DESIGN DEVELOPMENT NOTE
26/06/2025

PROJECT: JRL Ferry Island

TITLE: Appendix A - Restaurant Units and Louvre Provisions

DDN REF: LE481-DDN-48

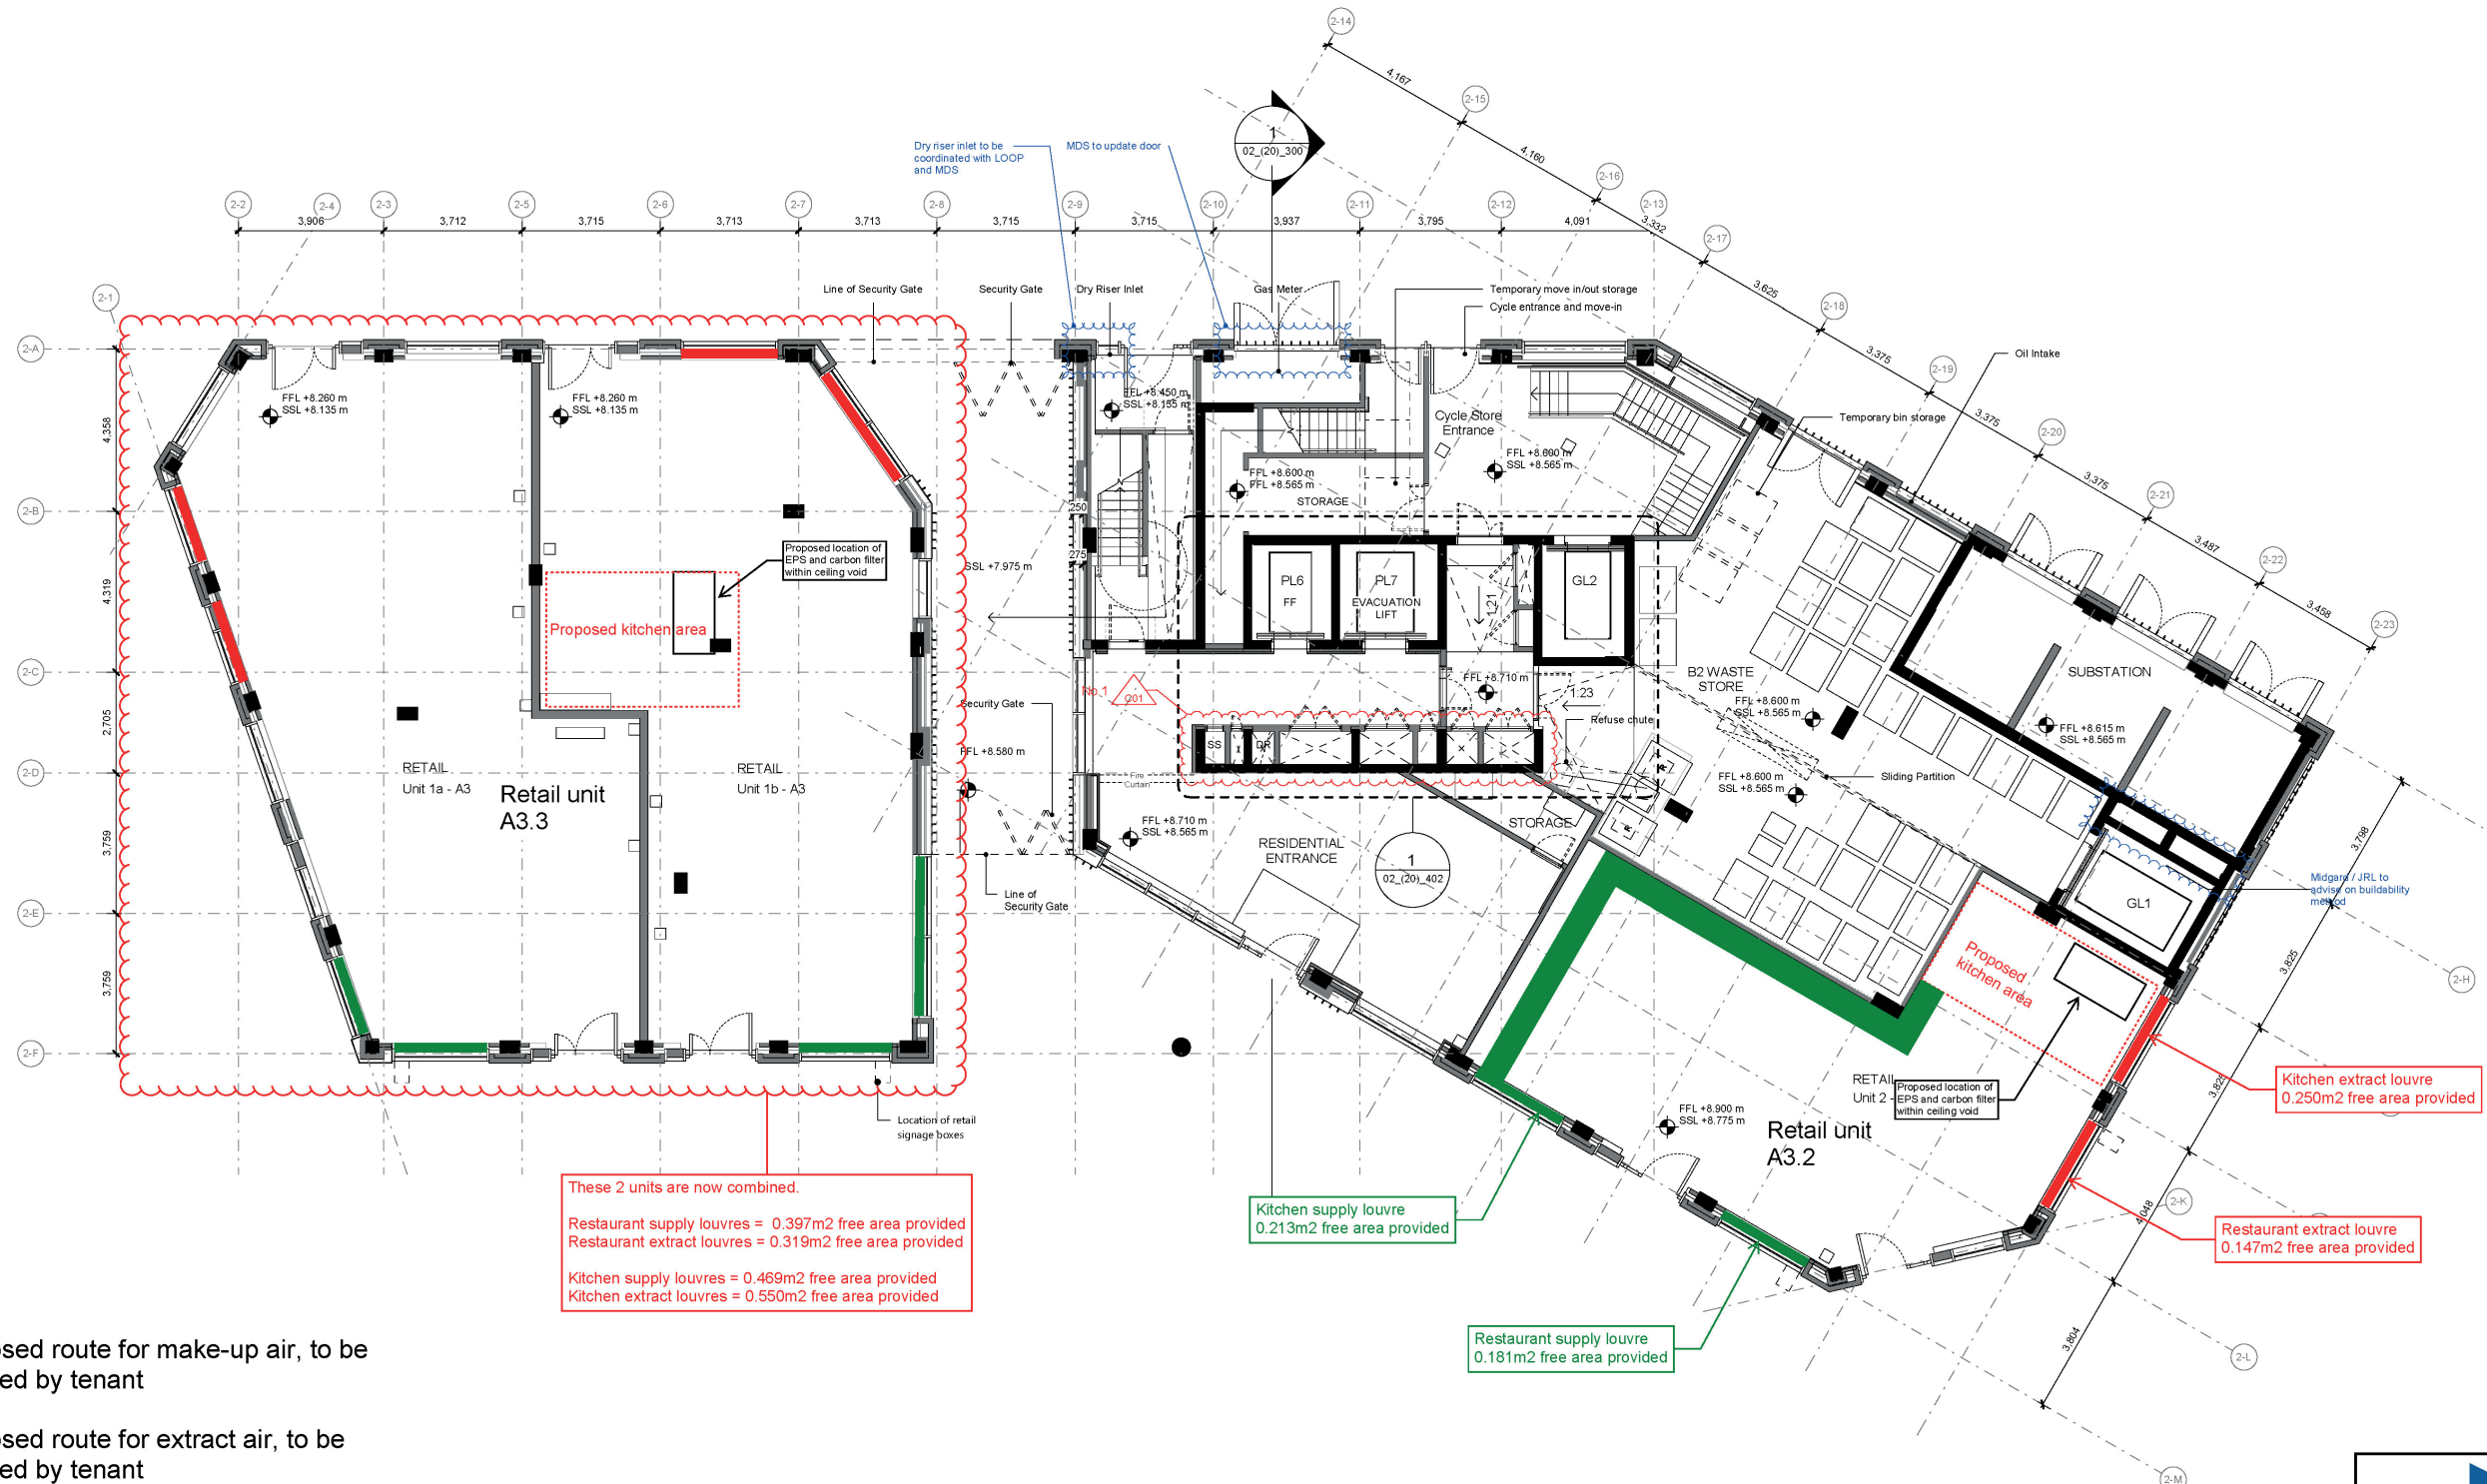
- Proposed route for make-up air, to be installed by tenant
- Proposed route for extract air, to be installed by tenant

It is proposed that the catering retail units will be provided with kitchen extract at ground floor level. To ensure odour control, the tenants will be required to provide an electrostatic precipitator (ESP) and carbon filter on their kitchen extract system. The ESP, carbon filter, and extract fan shall be located within retail units at high level (within ceiling void) prior to connecting to external louvres.
